Site at Former B&Q, Great Stone Road,
Trafford

**Rebuttal Proof of Evidence
Noise**

Document Reference: HA2021046/AC/9/D

Figure 1. Line source propagation diagram.

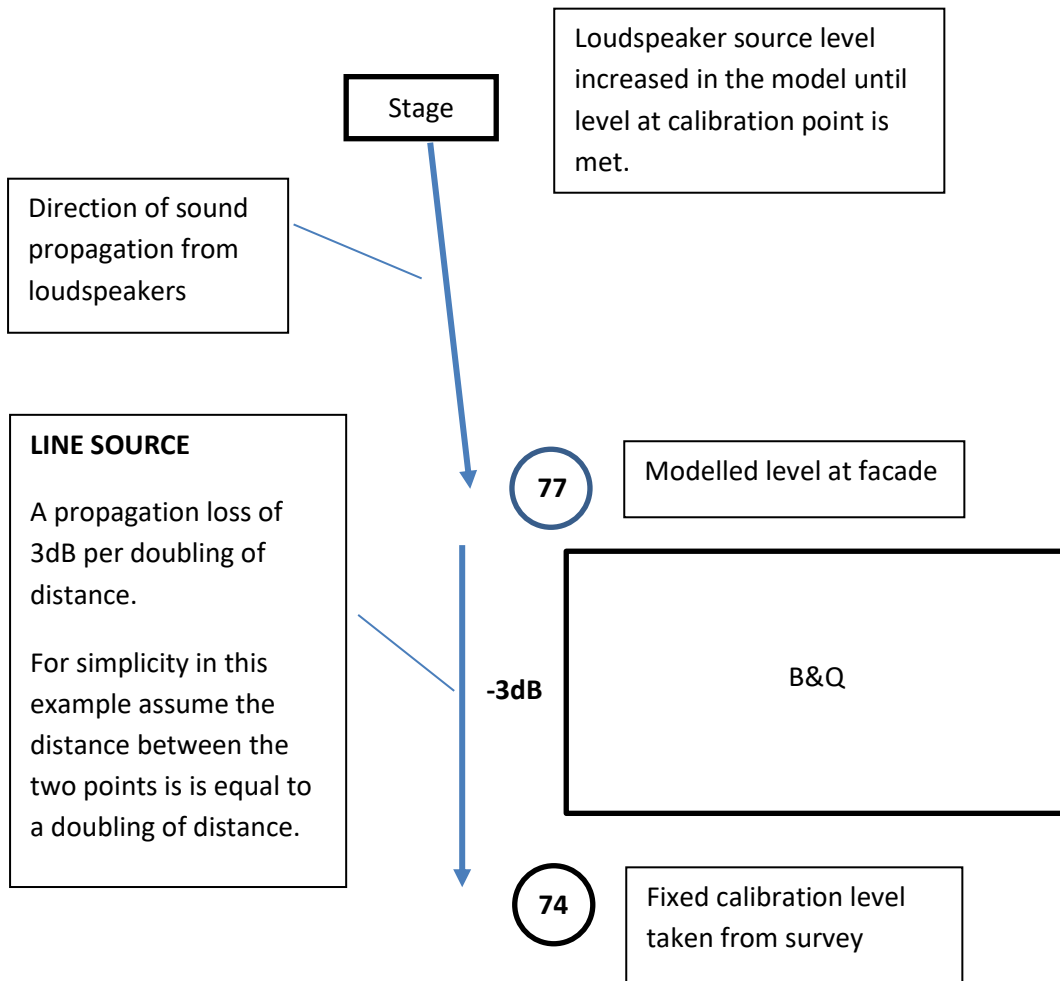
2.3.2 There appears to be a misunderstanding regarding the differences between the line source and point source propagation when applied to my particular model. I believe this misunderstanding is caused by my calibration point being behind the proposed façade rather than in front of it. My model is predicting noise from the calibration point **towards** the noise source whereas conventionally the noise would be predicted from the calibration point **away** from the noise source. I am satisfied that my assessment is entirely robust in this regard.

Figures 1 & 2 below demonstrate the position:

- 2.3.3 It can be clearly seen that using the point source propagation method results in a higher predicted level at the façade and therefore offers a worst-case scenario. Note that the scenario would be reversed if the calibration point and the prediction point were reversed, as in the case of LCCC's survey and model.
- 2.3.4 The model is only used to predict the level difference between the calibration point and at the proposed façade. The exact levels, placement, number and size of each speaker system are not required to be known. A calibration point takes away this uncertainty.
- 2.3.5 So long as there is a noise source in the proximity of the stage area and the directivity of the speakers are approximately correct the exact specification and placement of the speakers is not of great
